**ALTERATION TO A HISTORIC PROPERTY STAFF REPORT**

**Site:** 58 Meacham  
**Case:** HPC 2015-051

**Historic Name:** Henry R. Glover House  
**District(s):** Campbell Park/Meacham Road LHD

**Date of Application:** July 27, 2015  
**Legal Notice:** *Alter front porch and rear steps; Remove fire escape.*  
**Staff Recommendation:** Approval with conditions  
**Date of Public Hearing:** August 18, 2015

*Fig. 4 Stairs, decks and escapes*

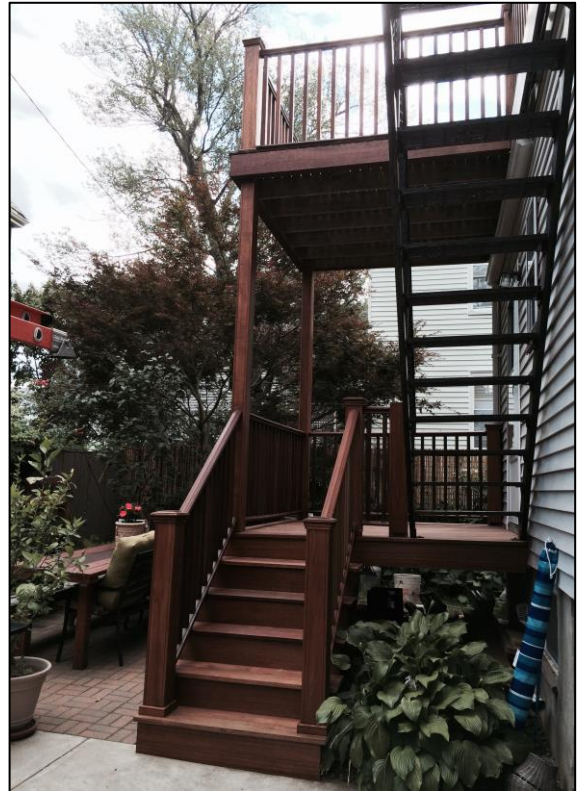
**Staff comments:** The proposed work complies with items D, E, and F. Replacing the turned wood columns on the front porch with square ones is more in keeping to the style and period of the structure. Replacement of the deteriorating metal fire escape appears necessary from a safety perspective. It should be noted that the extant metal escape and stairs are not original to the building. Replacing the metal portions with wood (mahogany) brings these elements of the structure into keeping with the rear decks, landings and stairs that have already been replaced, providing a cohesive look to the rear of the building. The applicant will need to apply for appropriate building permits from the Inspectional Services Division (ISD) before work can begin.

**Condition 4** – Applicant shall finish the replaced fire escape and stairs on the rear of the house in the same manner as the existing portions of the fire escape and stairs that run from the second floor to the ground.
